**CITY OF LA VISTA  
PLANNING DIVISION**

**RECOMMENDATION REPORT**

Multi-family housing named Cimarron Terrace

RE: Rezoning & Conditional Use Permit Reviews 2008  
Lot 380, Cimarron Woods  
First Review of Preliminary PUD for Cimarron Terrace  
TD<sup>2</sup> File No. 171-357.2

PRELIMINARY PLANNED UNIT  
DEVELOPMENT LANDSCAPE PLAN

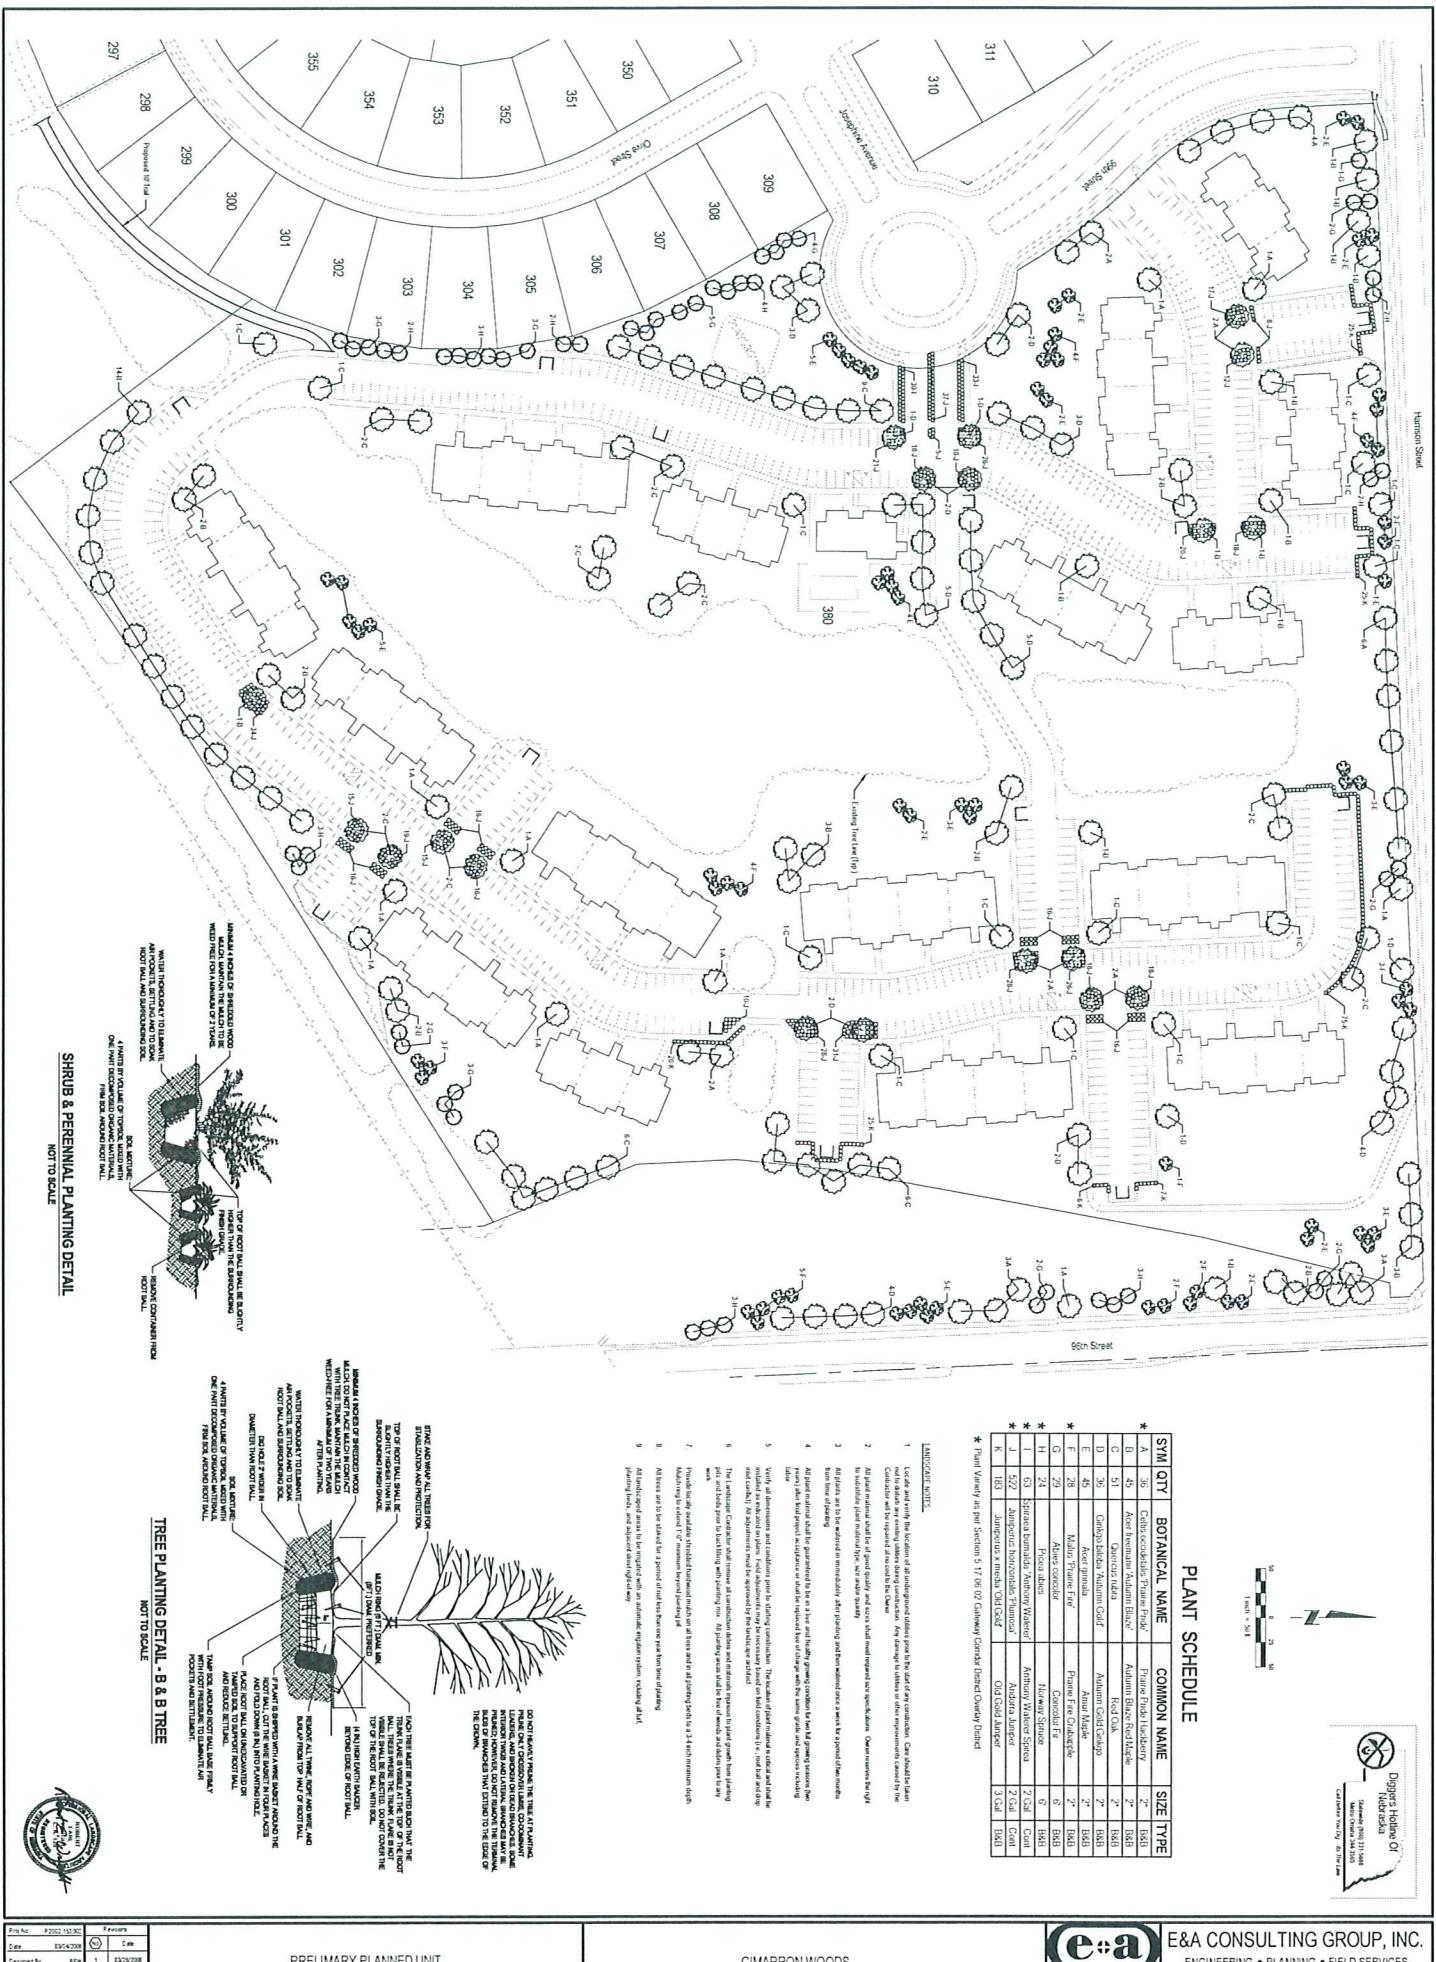
1. The property line along Harrison Street and the 96<sup>th</sup> Street right-of-way are planned to be landscaped in a manner consistent with the existing landscaping in Cimarron Woods.
2. Landscaping is also proposed around parking areas in Cimarron Terrace. These plantings should provide a visual buffer for the "gateway corridor" roads.
3. Some of the existing trees and vegetation will be conserved within the development. The developer proposes a narrow road cutting through the existing groves of trees at three locations on the property. Fill material for building sites and parking lots will likely cause trees to be removed. Additionally, installation of the proposed stormwater detention areas will likely cause existing trees to be removed.
4. The Landscape Plan will be reviewed in detail at the time of Conditional Use Permit review.

PRELIMINARY PLANNED UNIT DEVELOPMENT

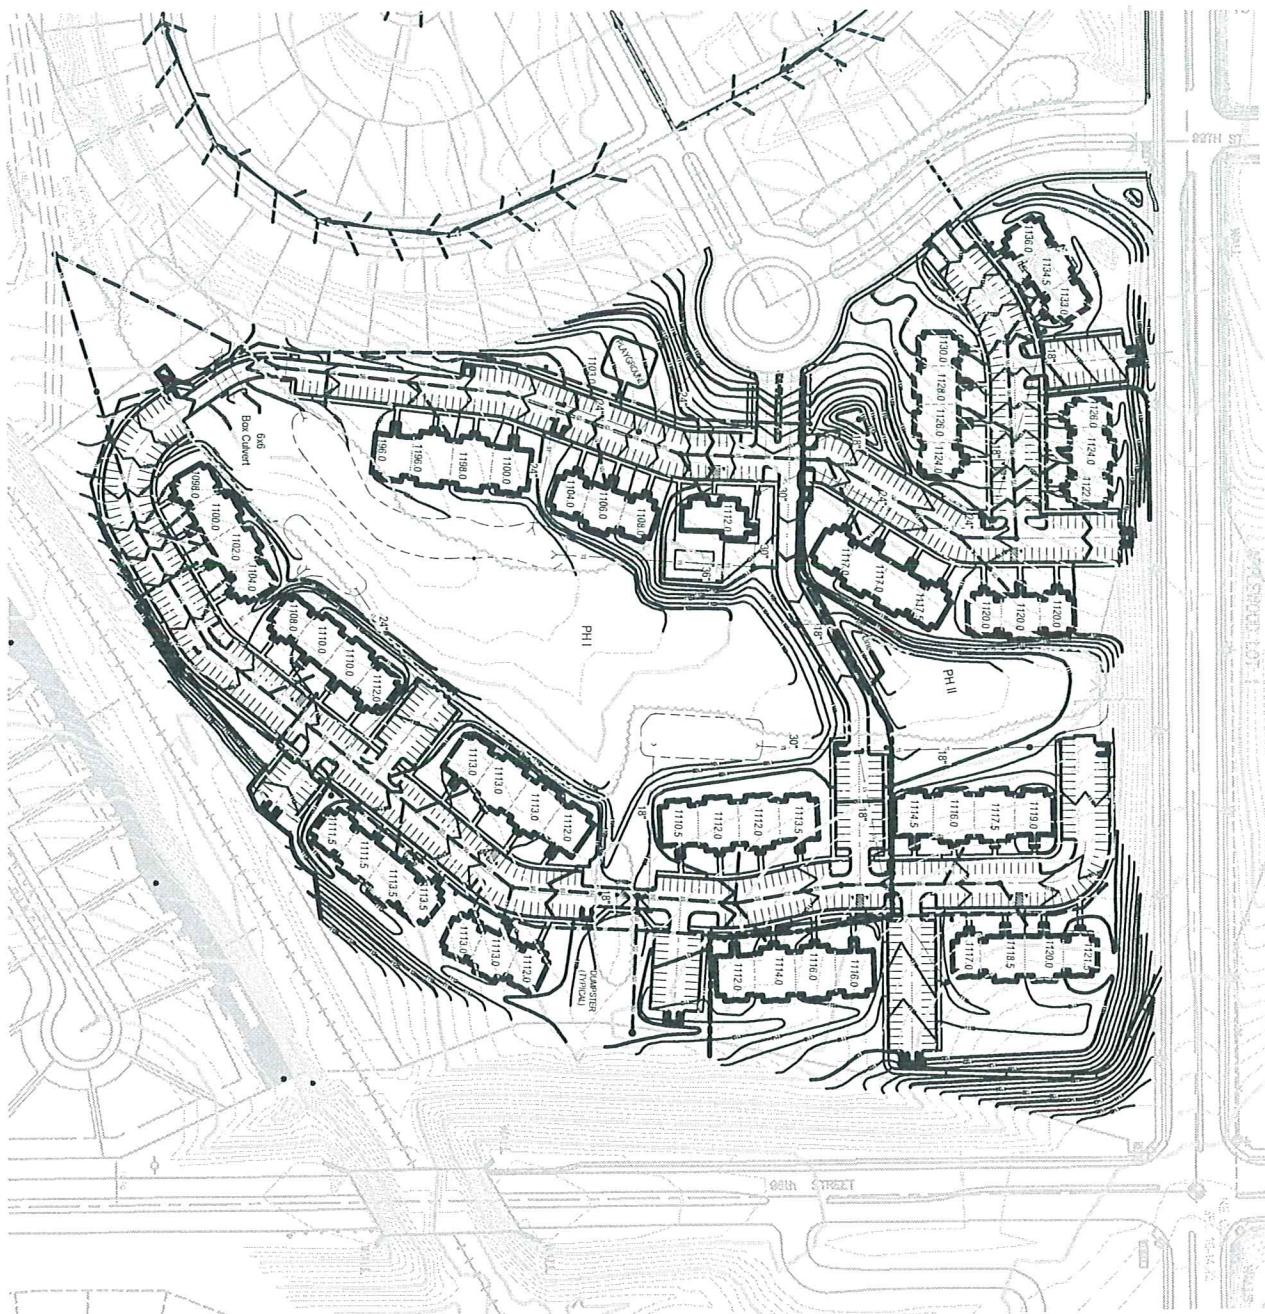
1. The Preliminary PUD Plan and application refers to the property as being zoned R-1 (PUD). This needs to be revised on the Final PUD Plan to read R-3, PUD-1 zoning.

14. The Preliminary Planned Unit Development plan shows the legal description as Lot 308. This is actually Lot 380. This is a minor issue but needs to be corrected.

15. The vicinity map on the Preliminary Planned Unit Development plan needs to be a more current map showing the existing street pattern to the east, south, and west of the site.
